CASE NO. FP-2026-0011

ORDER OF CONDITIONAL
APPROVAL OF FINAL PLAT

STAFF REPORT
COMMUNITY DEVELOPMENT DEPARTMENT

HEARING DATE: 6/16/2026
TO: Mayor & City Council
FROM: Sonya Allen, Associate Planner
208-884-5533
SUBJECT: Tanner Creek No. 2
FP-2026-0011
LOCATION: Generally located on the north side of I-84, 1/4 mile west of S. Meridian Rd., in the NE 1/4 of Section 13, T.3N., R.1W.

B. Final Plat (dated: 6/4/26)

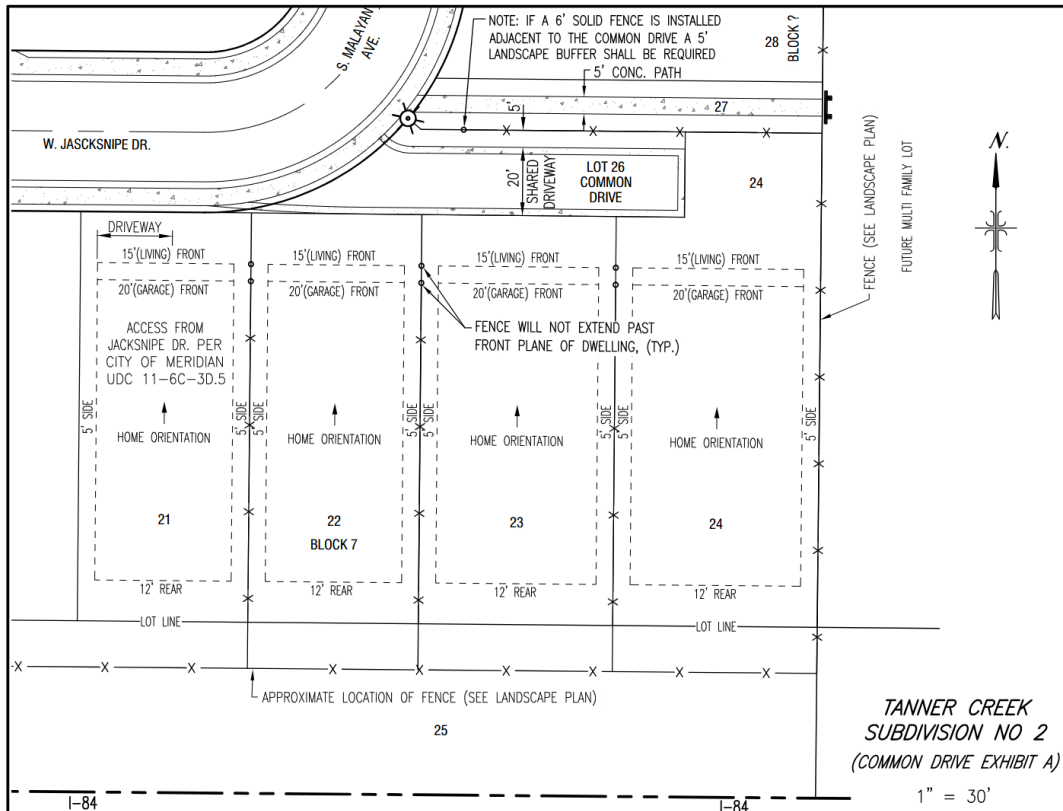
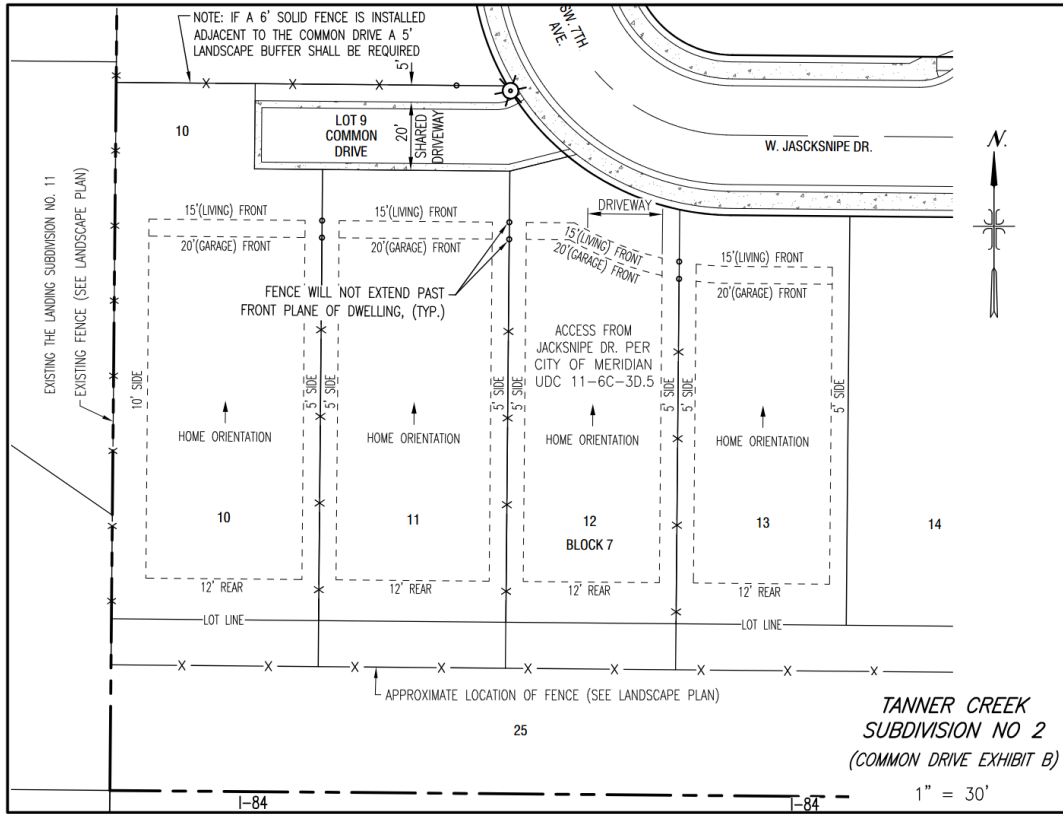
- a. Note #11: Include the recorded instrument number of the ACHD temporary license agreement.
 - b. Note #13: "Common lots Lot 9 and ~~34~~ 26 in Block 7 are subject to a perpetual ingress egress shared driveway easement for the benefit of Lots 10, 11, ~~42~~, 22, 23, and 24 in Block 7 . . ."

- c. Depict zero (0) lot lines where single-family attached and townhome units are proposed to span over property lines.
 - d. The public alleys shall have a concrete ribbon curb, not a rolled curb and gutter, as set forth in UDC 11-6C-3B.5 – revise the construction drawings accordingly. The entrance to the alley from the public street shall provide a minimum twenty-eight-foot inside and forty-eight-foot outside turning radius. No parking shall be allowed on either side of the street within 50 feet of the alley entrance as measured from the centerline of the alley – the curb should be painted red to signify no parking or signage shall be erected accordingly.

- e. Include the Book and Page numbers of the Tanner Creek Subdivision No. 1 plat graphically depicted on Sheet 1.
 - f. Include the recorded instrument number of the 33' access easement graphically depicted on Sheet 1.

- g. If Lot 12, Block 7 isn't taking access from the adjacent common driveway, the street frontage shall be a minimum of 30 feet, measured as a chord measurement, as set forth in UDC 11-2A-3B.1.

- h. The common driveway lots (i.e. Lots 9 and 26, Block 7) shall be extended further in length to allow for vehicles to back out and turn around.

C. Common Driveway Exhibits

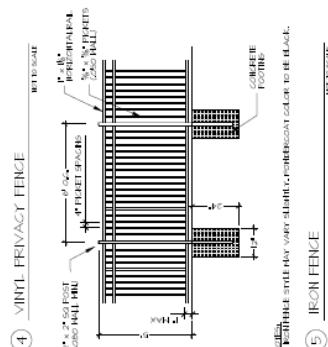
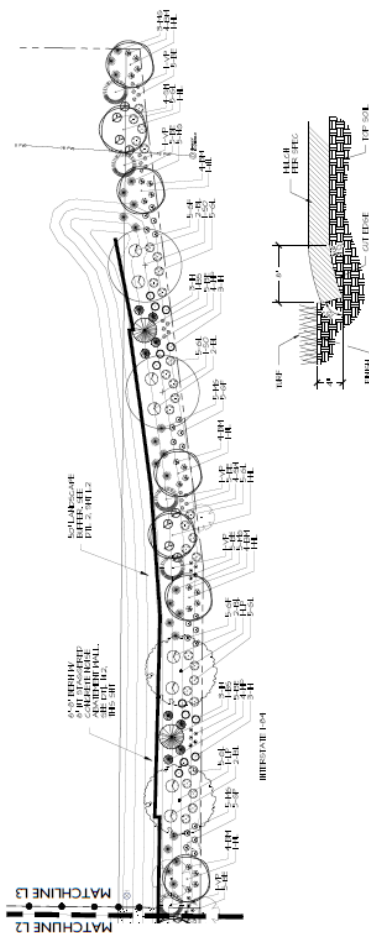
5. The landscape plan shown in Section V.C, prepared by Jensen Belts Associates, dated 5/29/26, shall be revised as follows:
 - a. The common driveway lots (i.e. Lots 9 and 26, Block 7) shall be extended further in length to allow for vehicles to back out and turn around.

8. Address signage shall be provided at the public street for homes accessed via common driveways for emergency wayfinding purposes.
9. Comply with the common driveway exhibits included in Section V.C above and the associated standards in UDC 11-6C-3D for common driveways.
